KD8 (-B) Modular Door Station(Main Module)

Release Note (2025-08-25)

Device Model	Firmware Version
DS-KD8003-IME1(B), DS-KD8003-IME1(B)/Surface DS-KD8003-IME1(B)/Flush, DS-KD8003-IME1(B)/S DS-KD8003-IME1(B)/NS, DS-KD8003Y-IME2 DS-KD8003Y-IME2/S, DS-KD8003Y-IME2/NS DS-KIS602(B), DS-KIS702Y	V3.7.1_build250819

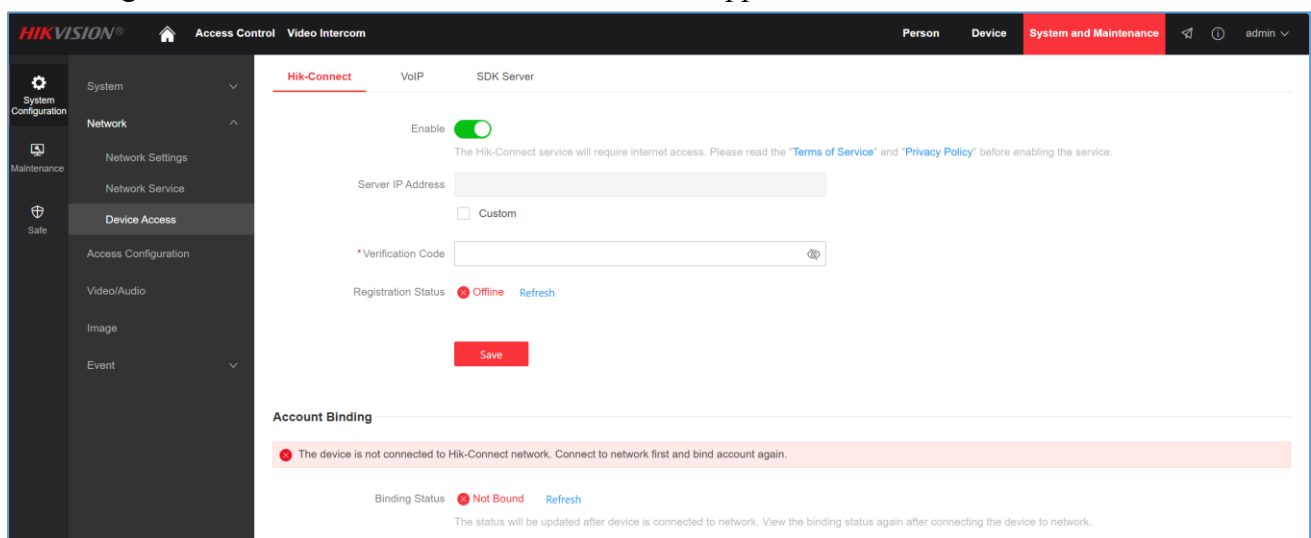
1. Update to new webpage UI

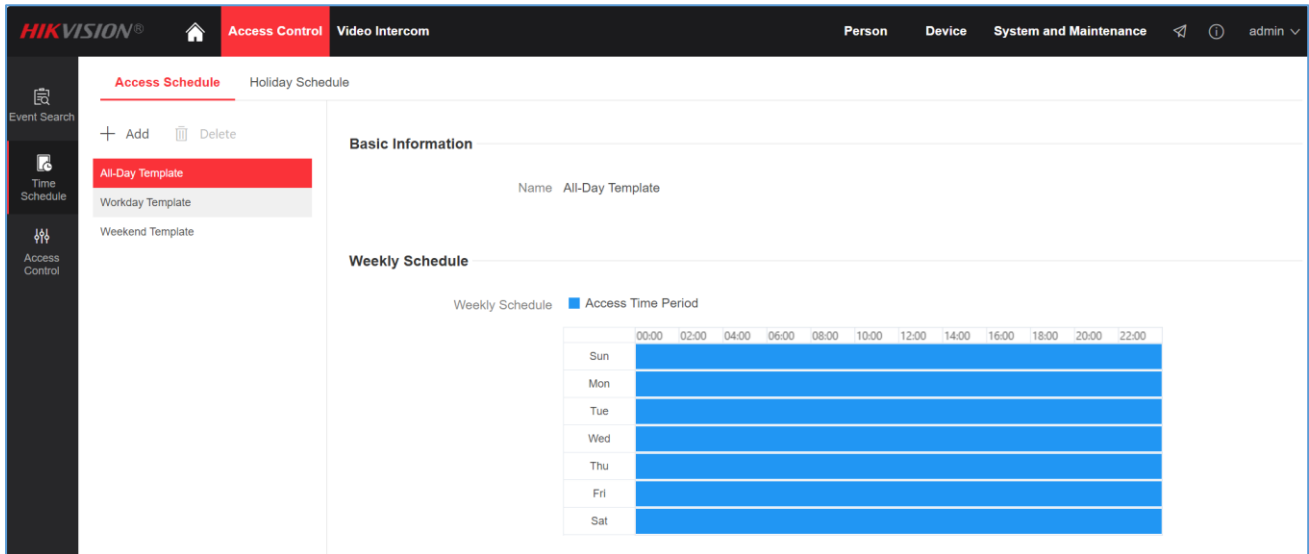
- Support PIN code and 2 modes: Device-Set Personal PIN and Platform-Applied PIN. And the

input format on keypad is same as public password: **#PIN#**

Note: a) When it's in platform mode, the PIN can only be configured from iVMS-4200, HikCentral and Hik-Connect Team mode.

b) If only single device, it's recommend to use Device-Set Personal PIN, which is easier to configure from webpage; If multiple devices, it's recommend to use Platform-Applied PIN and manage personnel and PIN from software and duplicate PIN is not allowed

c) If you want to add personal PIN from indoor station, please make sure the mode is platform-applied personal pin.

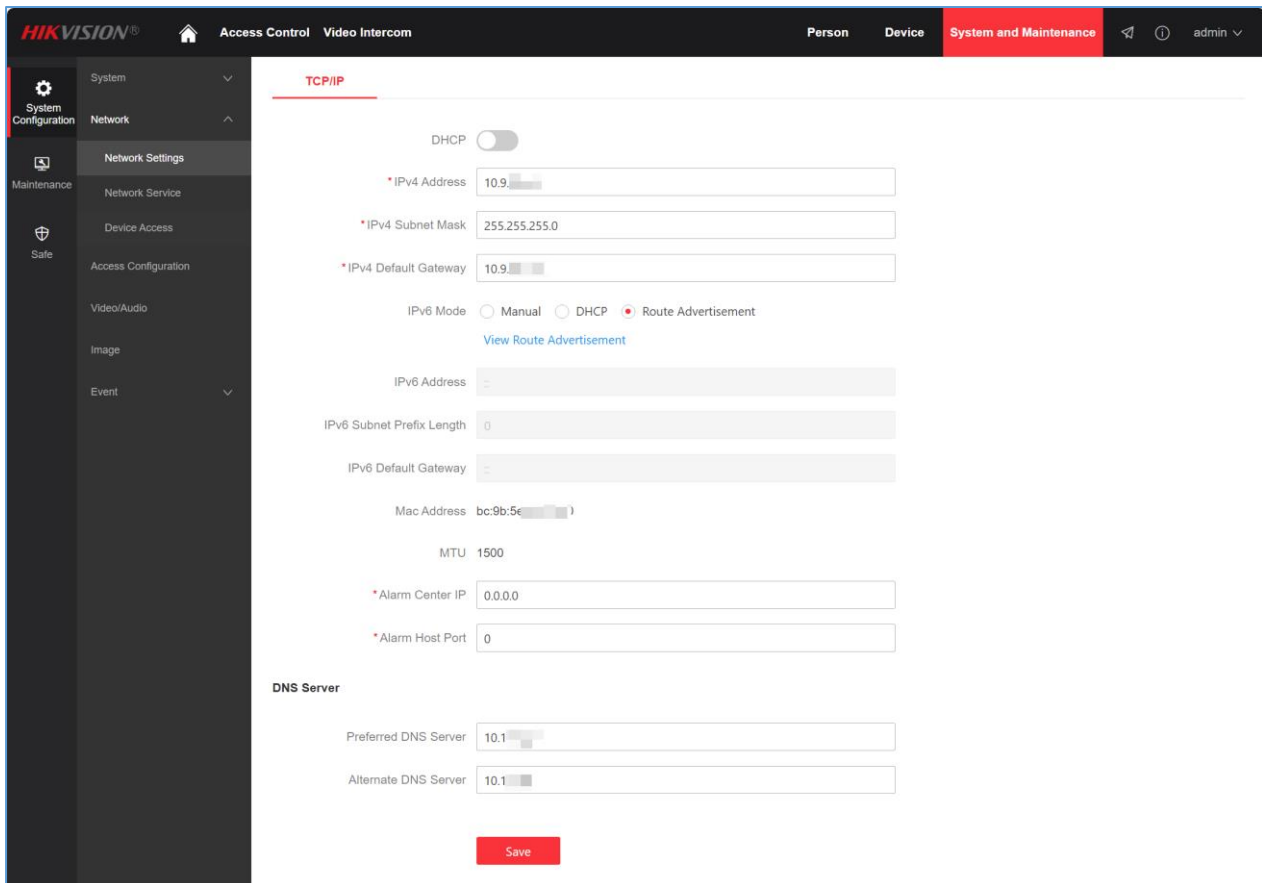
4. Support Access Schedule and the verification will only work during the valid time period.

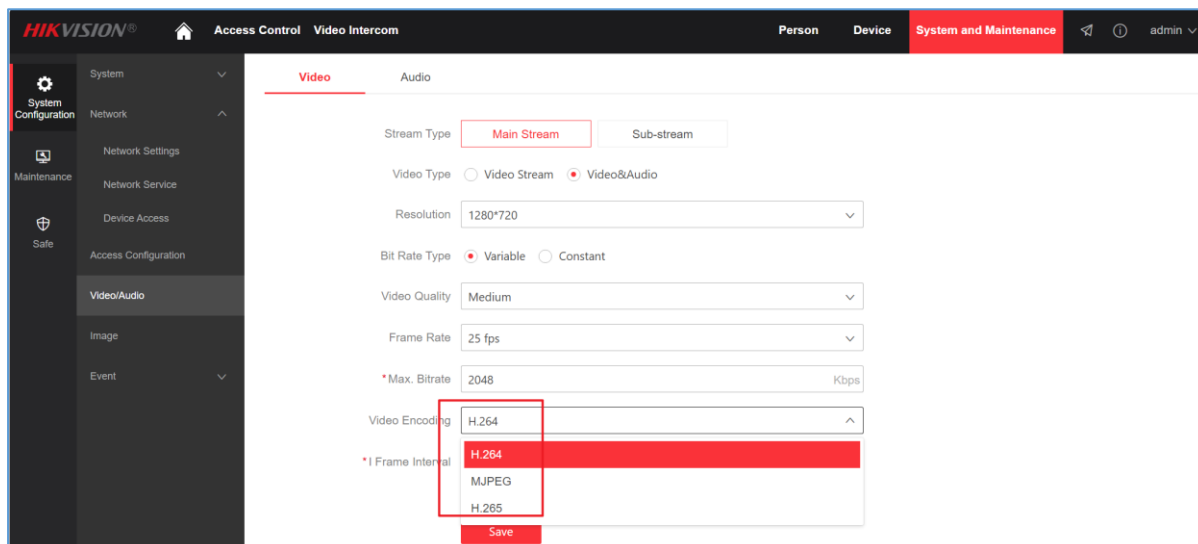
5. Support IPv6 network

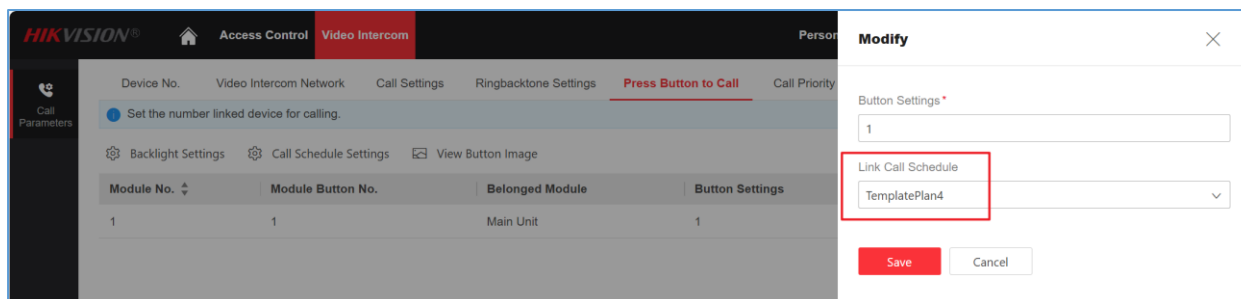
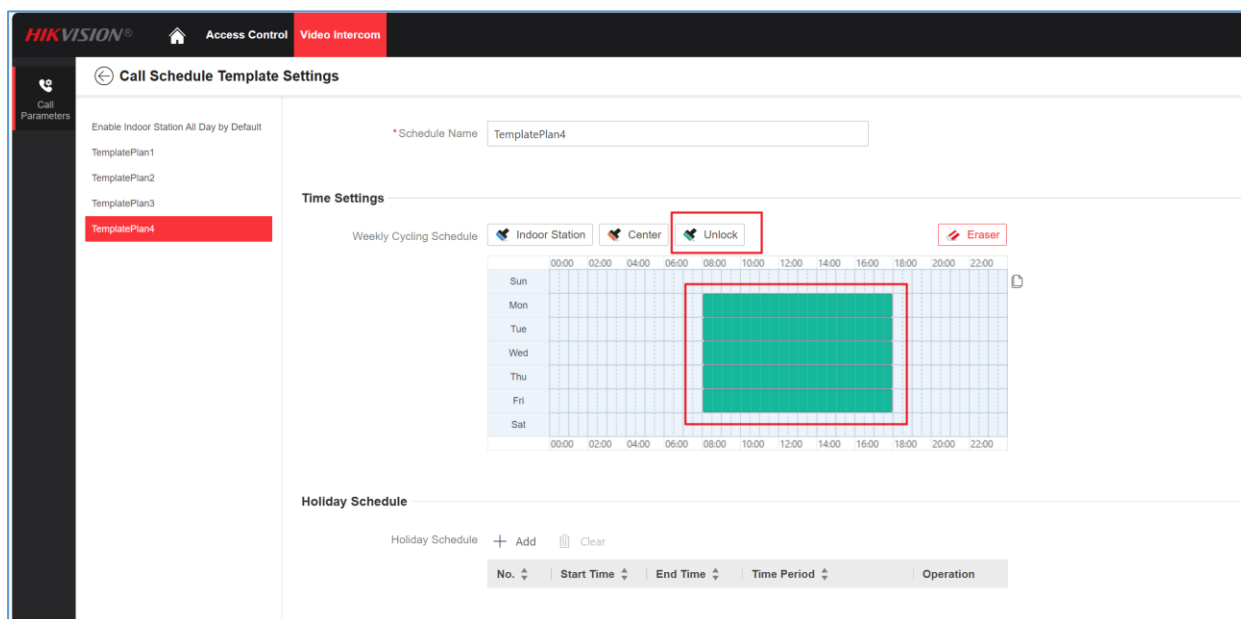
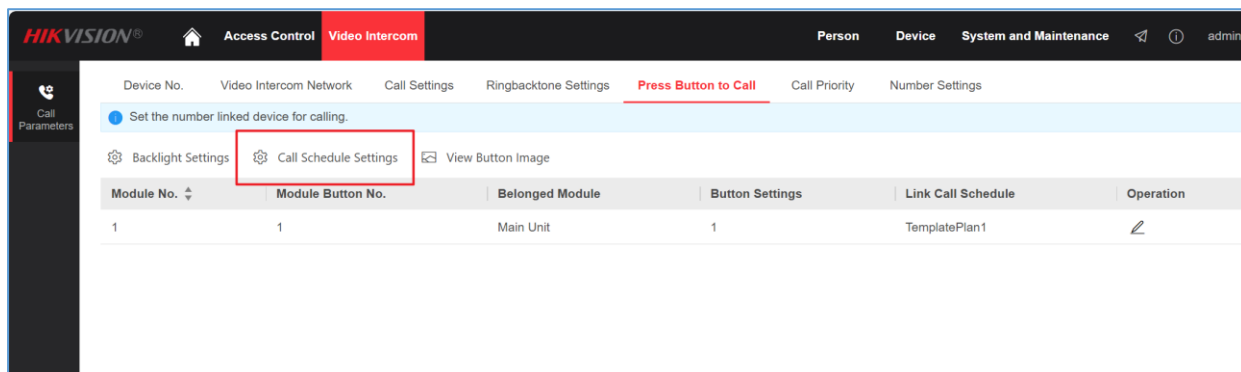
10. Support trade button (automatically unlock door after receive call) function.

For example, if you set same schedule as below pictures, the door will unlock automatically after receive the call from button1 between Monday to Friday 8:00-18:00

- 1) Each button (of main module and nametag DS-KD-KK or DS-KD-K12 module) can only be linked to one template only.
- 2) Only lock1 will be open automatically, lock2 doesn't support trade button function.

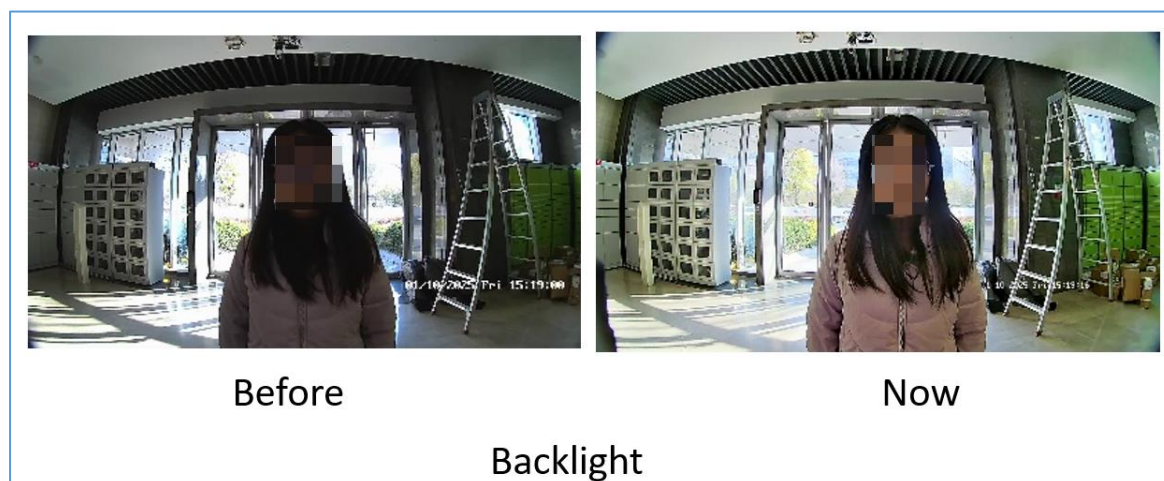
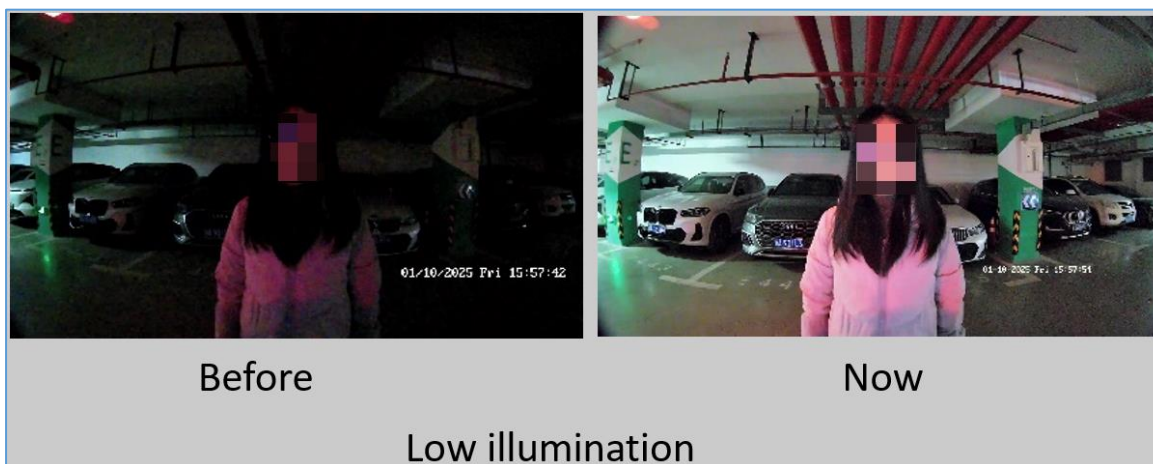
2. Video quality improvement

- 1) WDR enabled by default.
- 2) Video quality remains clear even when backlit or in low light

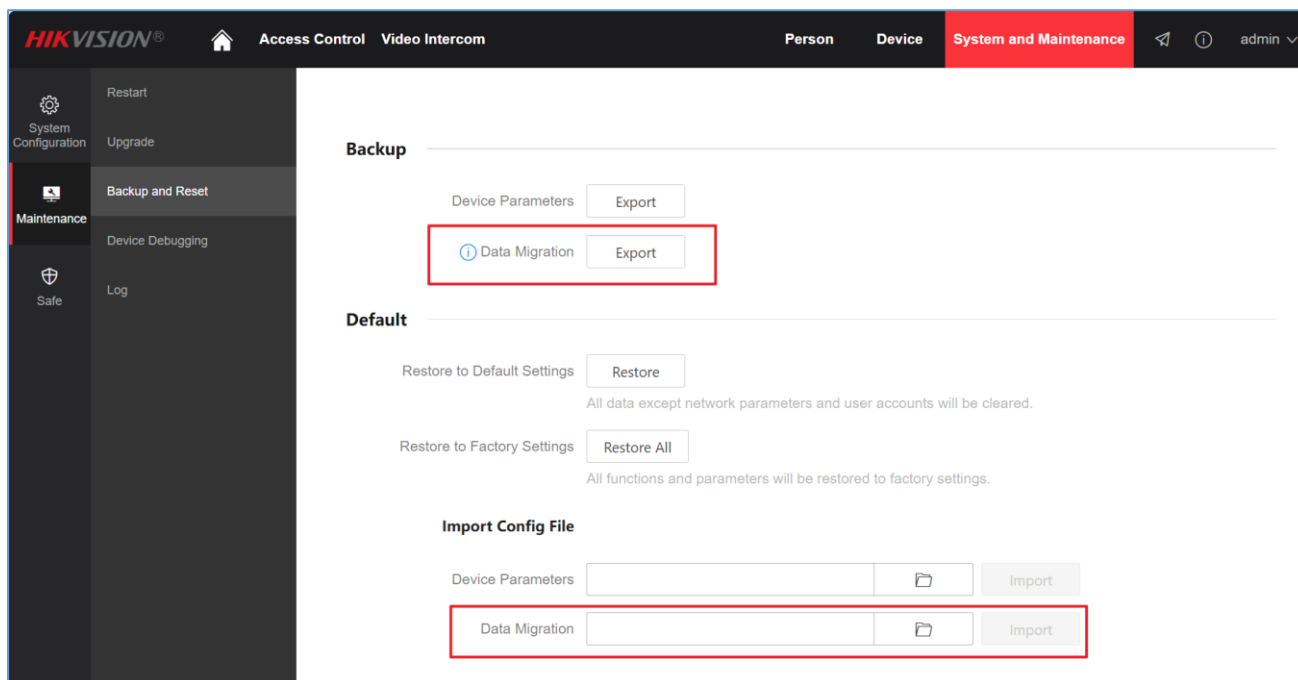
4. Support 2 sip lines and input special characters in SIP number settings, including *.#+==-_/|0\$?[]{}

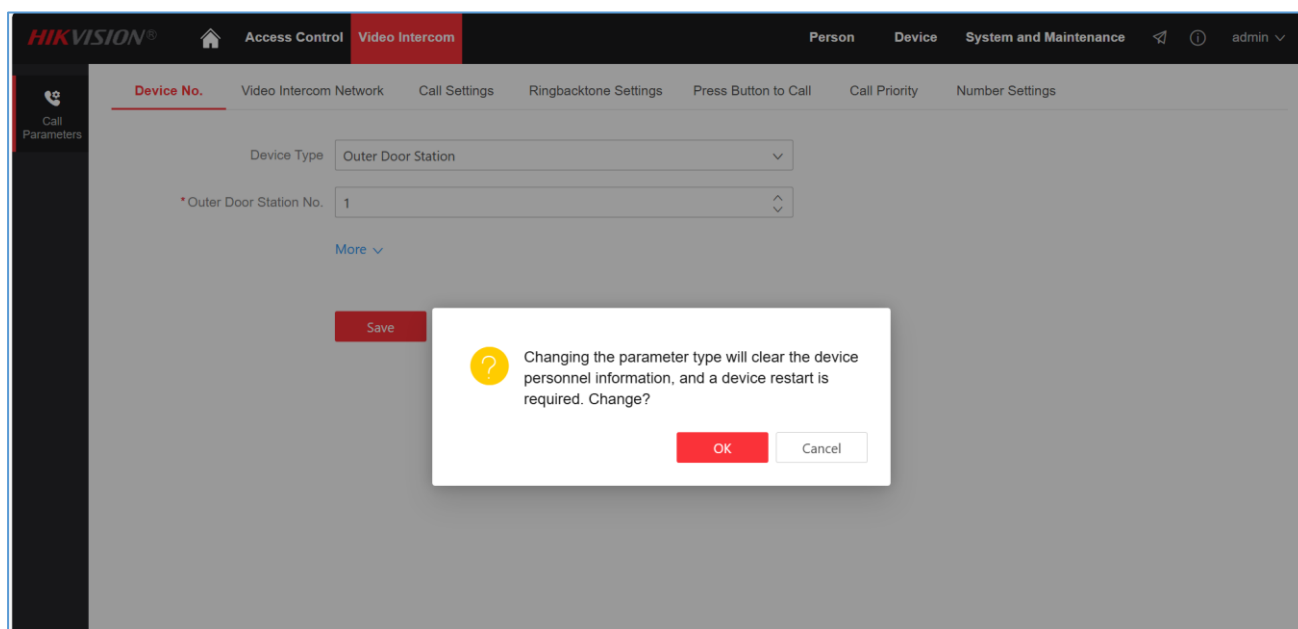
5. Support data export and import.

a. The data exported and imported devices should share same model and firmware version in

case of any data format incompatibility.

- b. The data includes user information, door station parameters configuration data, ringtone and etc.

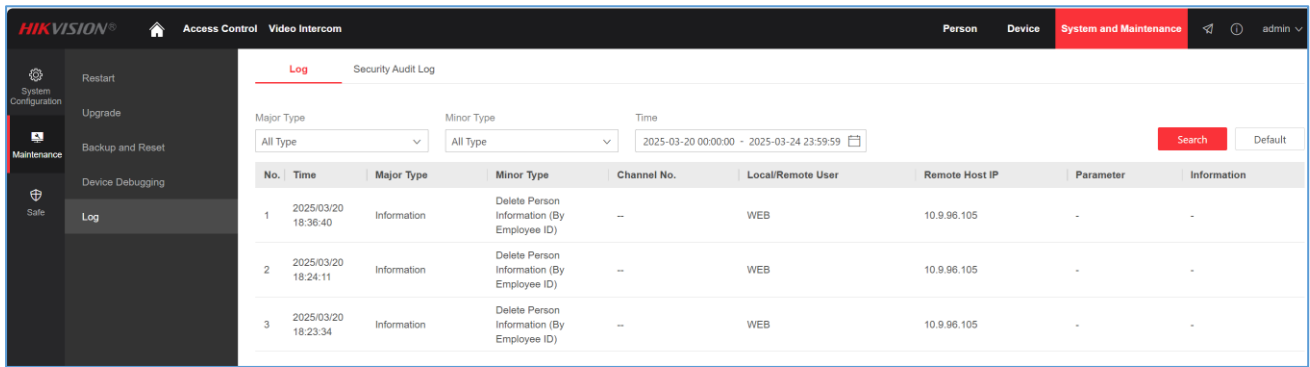
6. When changing the device mode between door station and outer door station, all personnel **data will be deleted**, please take care for the data loss, and add the prompt as below picture.
